CITY OF HOBART

CITY PLANNING COMMITTEE MEETING

6 PLN-18-351 20 Runnymede Street Battery Point - Appeal
File Ref: F21/20051; PLN-18-351

PLN-18-351 20 Runnymede Street Battery Point - Appeal**1. Background**

PROPOSED VIEW FROM SALAMANCA PLACE SHOWING 1970'S LENNA & PROPOSED LENNA IN BACKGROUND

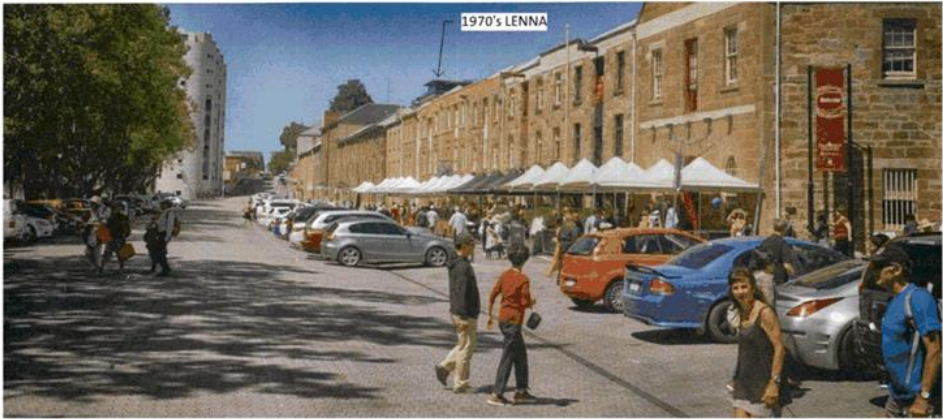
22. ... The building ..., as proposed by the modified plans, has less impact on street vistas along Runnymede Street. Similarly, the setbacks to the park will reduce the prominence of the building, regardless of whether the vegetation does or does not grow. The reduction in height of the building will reduce the visual impact from Salamanca Place.

The changes

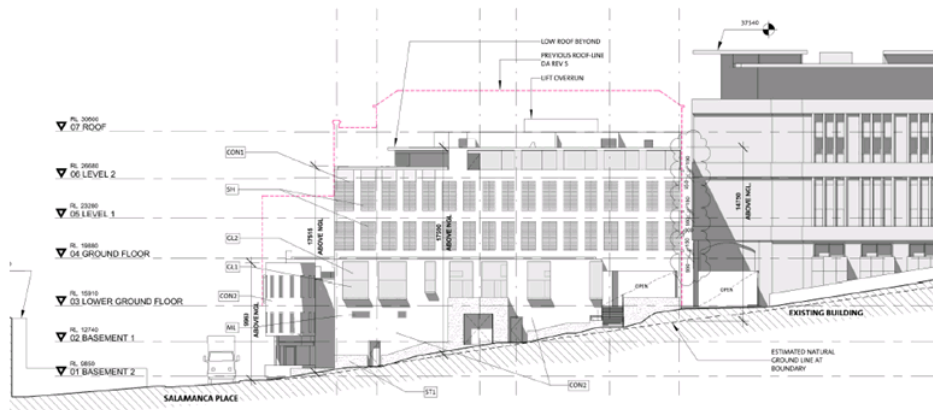
The amended proposal has been developed in response to these grounds, with the aim of achieving greater compliance with the planning scheme's discretionary provisions. The revised concept also reflects suggestions made by the proponent's cultural heritage consultants with the support of the Council's heritage officer. The amended proposal is lower than the original scheme, and

incorporates greater setbacks. It also includes modification to facade treatments and fenestration, and the deletion of incongruous 'feature' elements such as the conical cairn-like structure.

The modifications incorporated within the amended proposal are clearly intended to achieve greater compliance with the planning scheme.

- (a) Setback of basement level car parking from eastern boundary by 1.5m min;
- (b) Increased articulation of Salamanca Place façade;
- (c) Removal of external planter tubs and cone on Runnymede Street;

- (d) Removal of mast-like detailing elements;
- (e) Enclosure of guest terrace on Salamanca Place;
- (f) Increased masonry/glazing detail on corner turret;

- (g) Removal of sloped roof on penthouse level;
- (h) Replacement of the climbing frame for the vegetated wall on the Princes Park elevation;
- (i) Provision of planter boxes at each level to stimulate quick vegetation coverage of the Princes Park façade and a deep soil area at the base of the building due to the setback of the basement carpark;

- (j) Plantroom reduced in size and height (1.1m) to the minimum required for the lift overrun;
- (k) The Princes Park façade set back 1.5m and the upper floor is also set back a further 0.5m-1.9m;

- (l) The upper roof height (excluding the plant) reduced to RL 30600;
- (m) Increased setback of the Runnymede Street elevation by 3m above the podium (including balconies),

- (n) Change from horizontal to vertical glazing to the penthouse level facing Runnymede Street;
- (o) Detailing of the south facing façade on the Runnymede Street end including:

The changes

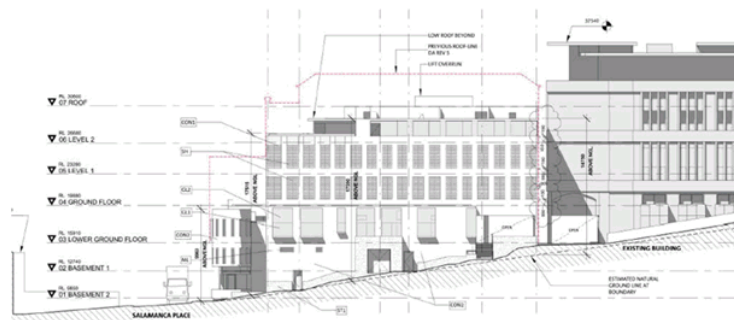
façade treatments and fenestration, and the deletion of incongruous 'feature' elements such as the conical cairn-like structure.

- (a) Setback of basement level car parking from eastern boundary by 1.5m min;
- (b) Increased articulation of Salamanca Place façade;
- (c) Removal of external planter tubs and cone on Runnymede Street;

- (d) Removal of mast-like detailing elements;
- (e) Enclosure of guest terrace on Salamanca Place;
- (f) Increased masonry/glazing detail on corner turret;
